TOLEDO - LUCAS COUNTY PLAN COMMISSIONS

TO: President Vanice S. Williams and Members of Council, City of Toledo
FROM: Toledo City Plan Commission, Lisa Cottrell, Secretary
SUBJECT: Special Use Permit for Used Auto Sales at 5057 Lewis Avenue
REF: SUP26-0012

APPLICATION FOR SPECIAL USE PERMIT FOR USED AUTO SALES

APPLICATION #: SUP26-0012
APPLICANT: David Daoud
OWNER: Maayah Daoud
ADDRESS: 5057 Lewis Avenue
PARCEL(S): 09-81087
ZONING: Regional Commercial (CR)
NEIGHBORHOOD: Mayfair Park
REPORT DATE: June 26, 2026
HEARING DATE: July 9, 2026
STAFF REVIEWER: Karcher

Proposed Site Plan.

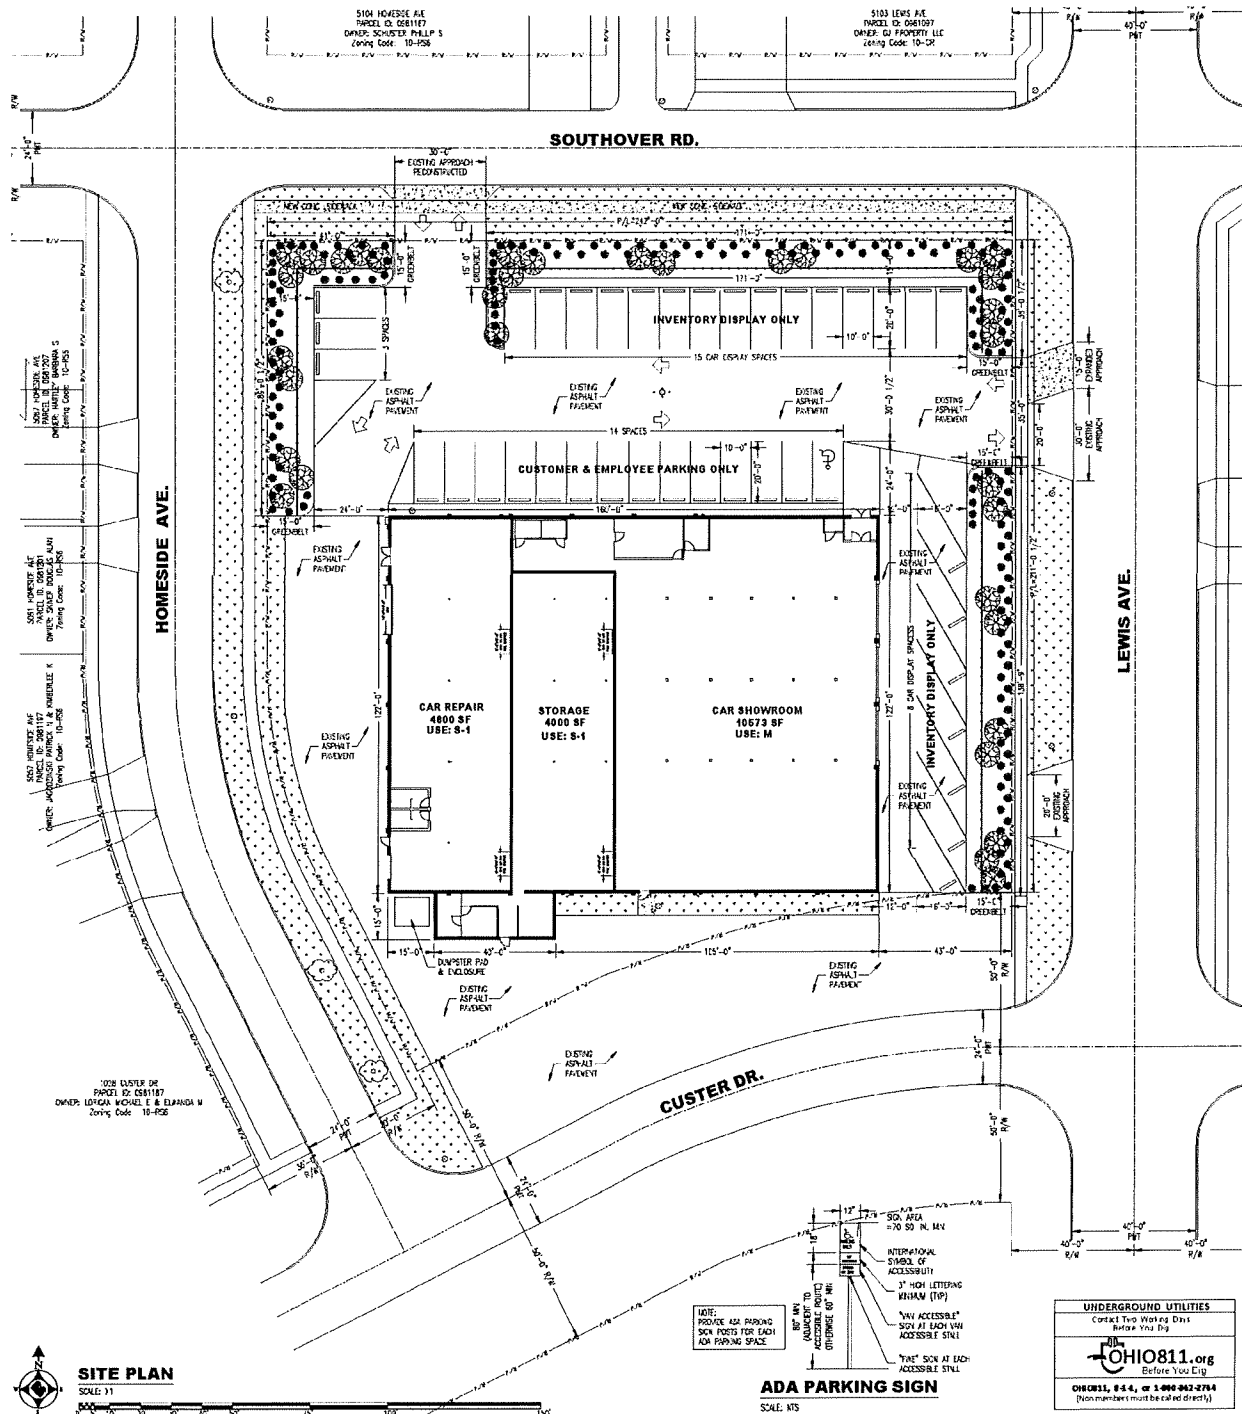
- (a) *Location (TMC§1104.0301)*. A 50-foot separation measured along the street frontage between any open display sales lot and a Residential district boundary line shall be maintained. The outdoor display area proposed for fifteen (15) cars along the northern property line will be impacted because of the Residential district to the north. The west six (6) display spaces are within the required separation distance and are therefore not permitted. – Not acceptable

- (c) *Outdoor Display Areas (TMC§1104.0302(B))*. Curbs or other substantial permanent barriers to prevent encroachment of the vehicles into the required setback and landscape areas are required. Wheel stops are depicted on the site plan for all display spaces; however, wheel stops do not meet this requirement as they aren't considered a substantial permanent barrier. – Not acceptable

- (e) *Fencing (TMC§1104.0305)*. Fencing for customer display areas shall meet the requirements of TMC§1105.0302 and TMC§1108.0203(H) for outdoor storage screening requirements. The site plan notes that a thirty-six inch (36") tall fence is provided in the proposed greenbelt; however, no fencing details are provided. – Not acceptable

- (a) *Off-Street Parking (TMC§1104.0300)*. The maximum number of parking spaces allowed is 1 per 5,000 square feet of open sales area, plus 1 per 500 square feet of enclosed sales area, plus 2 per service bay. Based on this, twenty-five (25) parking spaces are permitted for customers and employees. Seventeen (17) parking spaces are depicted on the site plan. – Acceptable
- (b) *Accessible Parking for Physically Disabled Persons (TMC§1107.1700)*. Based on the parking spaces proposed, at least one (1) van-accessible space is required. One (1) accessible space is depicted on the plan; however, the required eight-foot (8') abutting aisle is not shown on the site plan. The site plan shall be revised to show the required van-accessible parking space with eight-foot (8') abutting aisle. – Not acceptable

- (a) *Frontage Greenbelt (TMC§1108.0202)*. A minimum fifteen-foot (15') wide frontage greenbelt shall be provided along public rights-of-way, not including alleys. The frontage greenbelt shall include grass, trees and shrub plantings. At least one (1) tree must be provided for every 30 feet of lot frontage or fraction thereof. In addition, a solid evergreen hedge planting is required to screen the parking lot so that no headlights of any vehicles can be seen from the public street. Seven (7) trees are required along Lewis Avenue, nine (9) trees are required along Southover Road, and eight (8) trees are required along Homeside Avenue. The required fifteen-foot (15') wide frontage greenbelt and evergreen hedge are provided for the perimeter of the site where parking is proposed. In addition, trees in excess of what is required are provided along Lewis Avenue and Southover Road. Trees and landscaping shall be provided along the remainder of Homeside Avenue to screen the business from abutting residences and reduce the chance of any negative secondary effects. – Not acceptable

27. All test drives involving vehicles for sale shall be limited to main/major streets.
28. A 50-foot separation measured along the street frontage between any open display sales lot and a Residential district boundary line shall be maintained per TMC§1104.0301. The west six (6) display spaces along Southover Road are within the required separation distance. **Not acceptable as depicted. A revised site shall be submitted removing the west six (6) display spaces along Southover Road from the display area.**

30. Per TMC§1104.0302(B), display areas shall incorporate curbs and other substantial permanent barriers to prevent encroachment of vehicles into the required setback and landscaped areas. Wheel stops are depicted on the site plan for all display spaces; however, wheel stops do not meet this requirement as they aren't considered a substantial permanent barrier. **Not acceptable as depicted. A revised site plan shall be submitted that depicts the required curb or barrier.**

33. Per TMC§1107.1700, at least one (1) van accessible parking space shall be provided. One (1) accessible parking space is noted on the site plan; however, the required abutting aisle is not. **Not acceptable as depicted. Abutting aisle must be at least eight feet (8') in width to meet van-accessible parking space standards. A revised site plan with an eight foot (8') abutting aisle shall be provided.**

- h. The location, height and materials for any fencing to be installed and maintained. **Not acceptable as depicted. A revised site plan shall be submitted depicting fence details.**
